Access Compliance Report

Public Rights-of-Way

| Intersection ID: 46788 | Main Street: STOWE_ACRES_DR | Cross Street: ALMOND_HILLS_DR | Location: SW |
| ADA ID: 913DA4E035C9 | Ramp Type: Perp | Initial Pass/Fail: Fail | Overall Compliance: No |

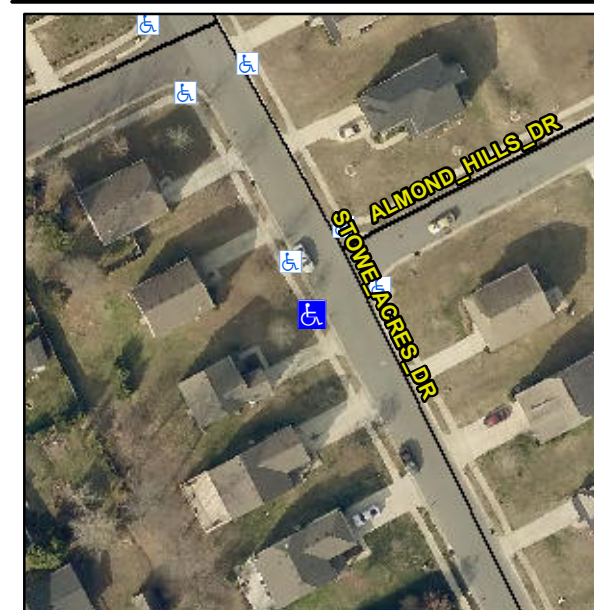
Not Found, R304.2.2, R304.5.3

| Compliance | Description | Data | Compliance | Description | Data |
|------------|-----------------------|------|------------|-----------------------------|------|
| N/A | Ramp Length (in) | 47.5 | No | Ramp Slope (%) | 10.5 |
| Yes | Ramp Width (in) | 48.0 | No | Ramp XSlope (%) | 2.9 |

Remove & Replace Entire Ramp.
